CITY OF KIRKLAND
Planning and Building Department
123 Fifth Avenue, Kirkland, WA 98033 425.587.3225
www.kirklandwa.gov

MEMORANDUM

To: Design Review Board
From: Jon Regala, Planning Supervisor
Date: December 1, 2015
File No.: DRV15-01765
Subject: VILLAGE AT TOTEM LAKE (AKA TOTEM LAKE MALL)
DESIGN RESPONSE CONFERENCE – Continued from November 2, 2015

BUILDING A - SOUTH ELEVATION

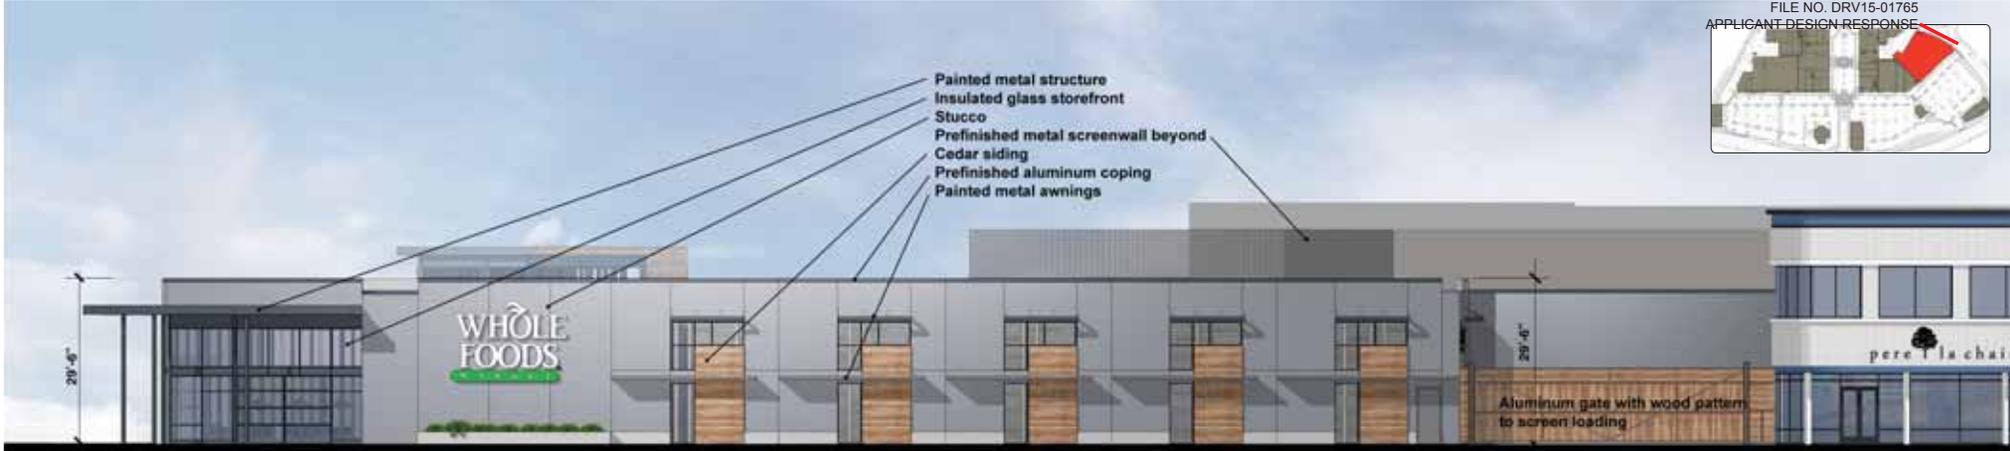
Provide more detail on the architecture of Building A.

BUILDING B - SOUTHWEST ELEVATION

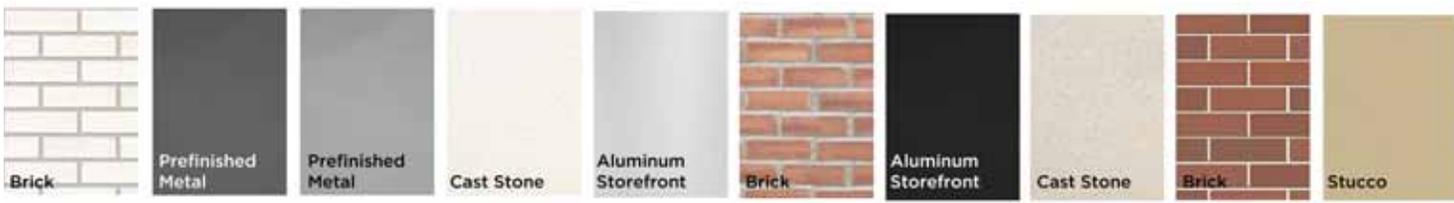
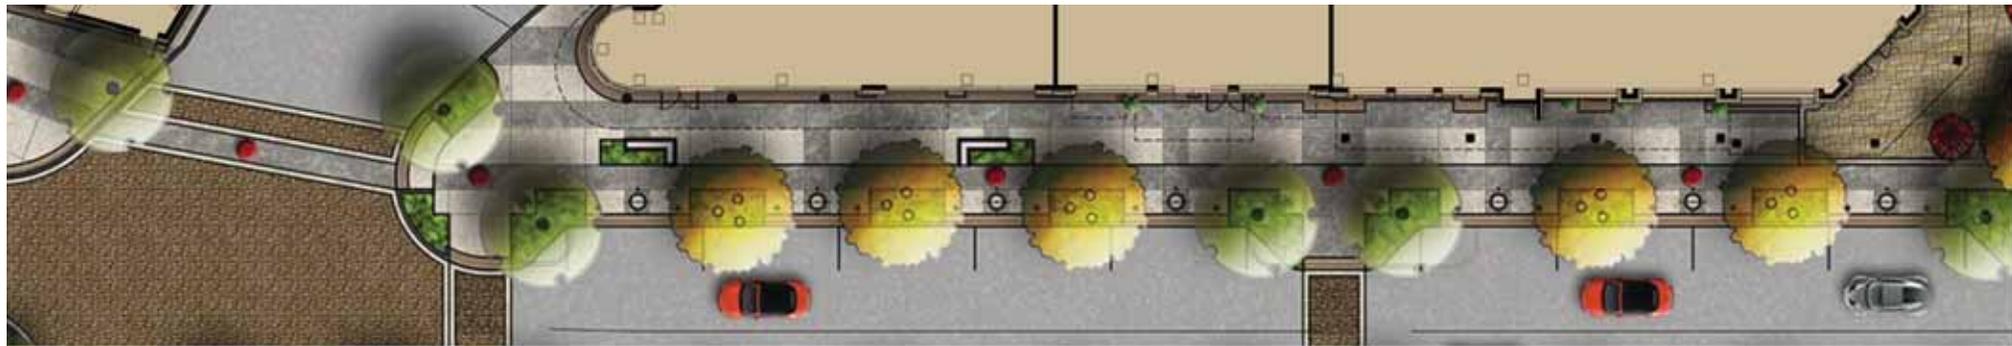
Provide more detail on the architecture of Building B.
